# **Addendum to the 2020 Initial Study / Mitigated Negative Declaration**

**Fortuna Wastewater Treatment Plant and  
Effluent Percolation System Upgrade  
Project, SCH No. 2020050104**

City of Fortuna

12 May 2023

FIGURE 1

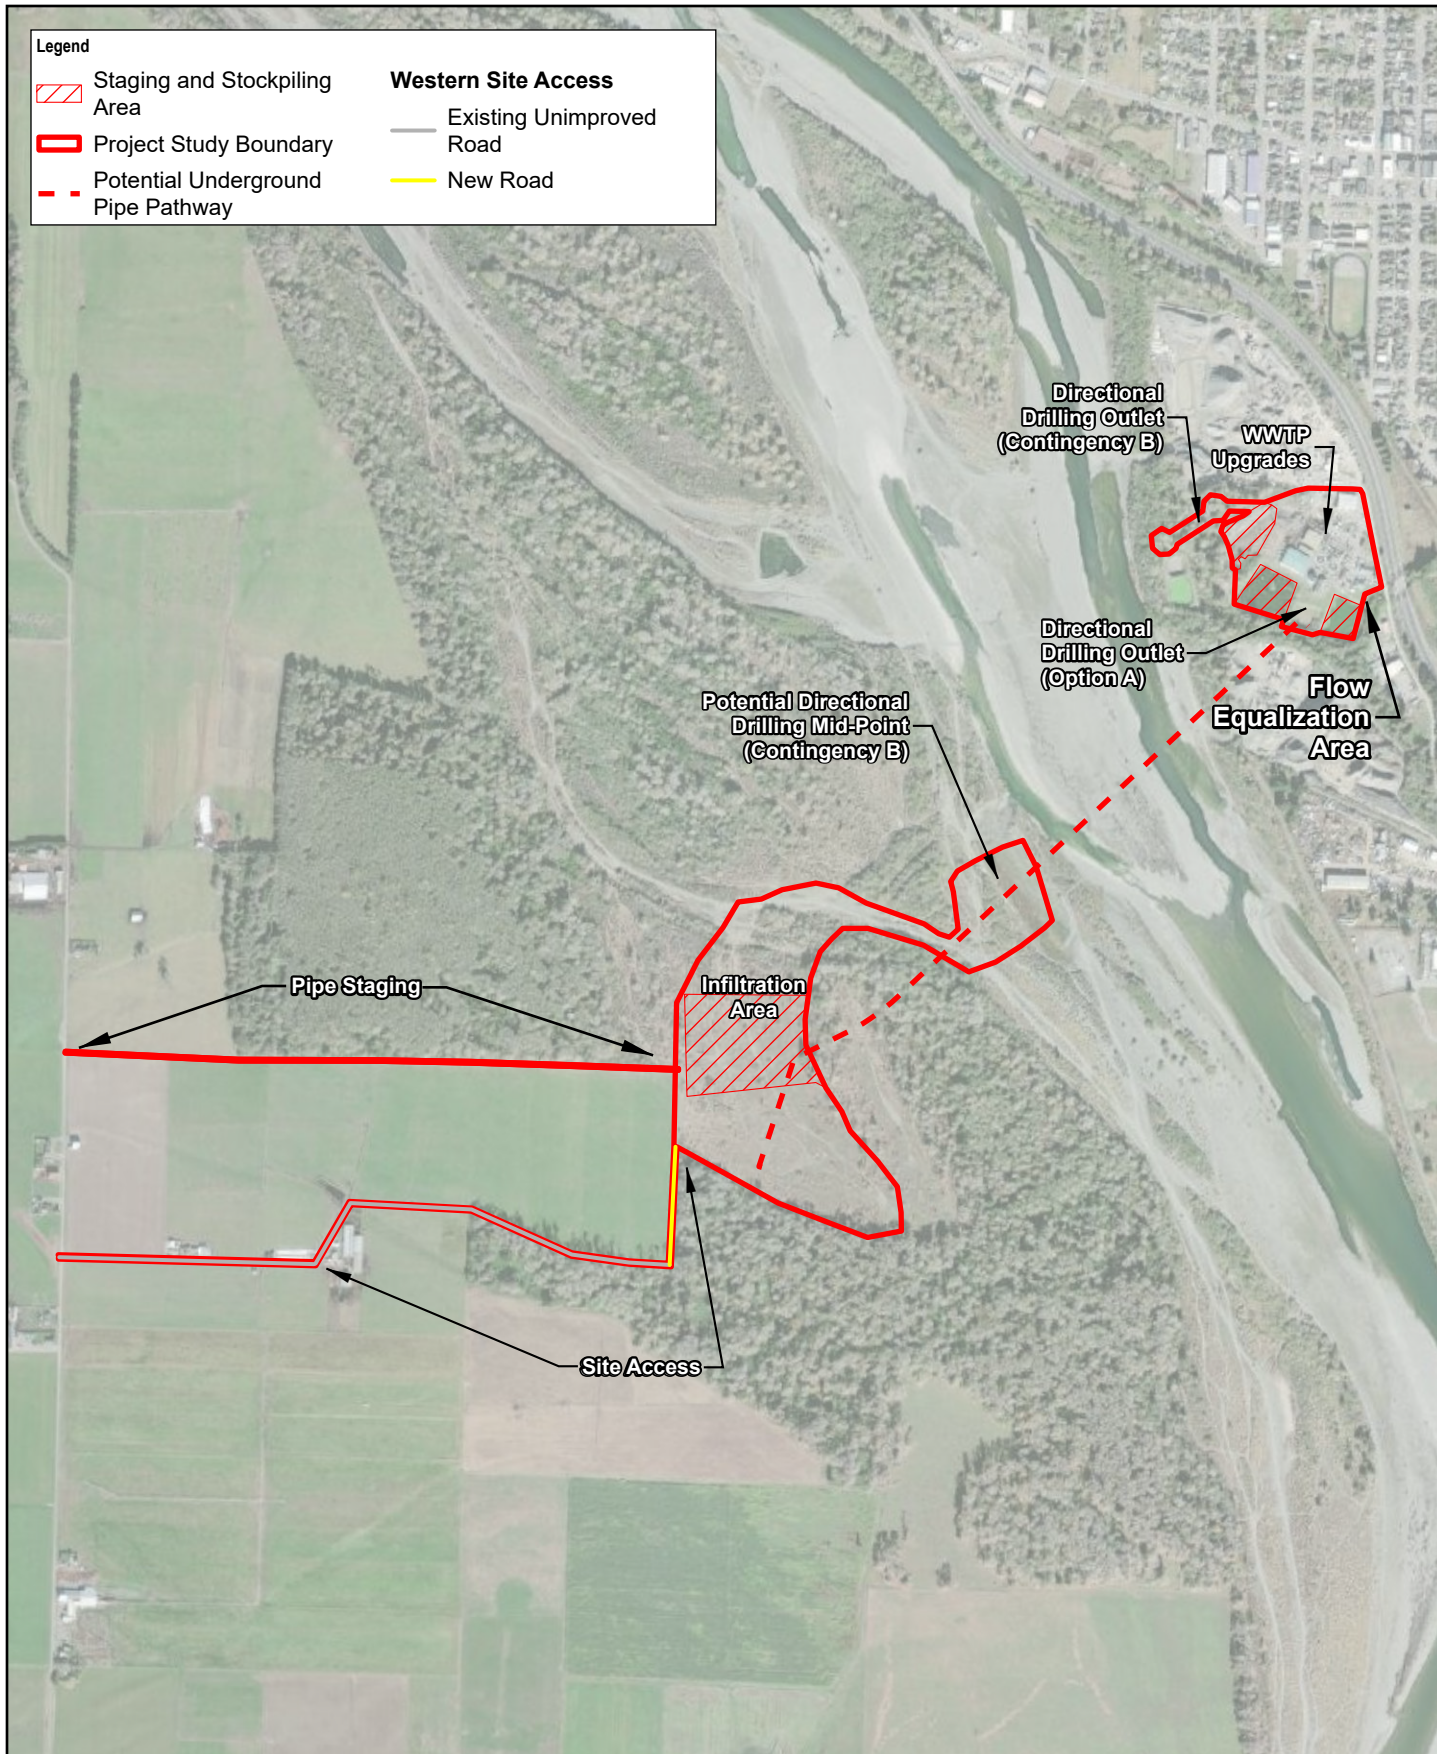
The Notice of Determination for the adopted Mitigated Negative Declaration (2020 MND) and Mitigation Monitoring and Reporting Program and approved the WWTP and Effluent Percolation System Upgrade project (project) was filed on July 15, 2020. Since adoption of the 2020 MND, the project design has been modified. Modifications are limited to improvements at the WWTP and include flow equalization system and upgrades to the existing storage ponds, a new phosphorus removal system, new backup generator, upgrades to the secondary and primary clarification system, upgrades to the anaerobic digester and associated systems, new solar panels and updates to the Supervisory Control and Data Acquisition (SCADA). Additionally, the project study area has been updated to identify the roadway anticipated to be used for site access and the full footprint of the existing WWTP; however, the project design footprint (staging and stockpiling, pipeline staging, infiltration area, WWTP upgrades, and directional drilling locations) would not be modified from that used in the 2020 MND. The proposed modified project study area is provided in Figure 1.
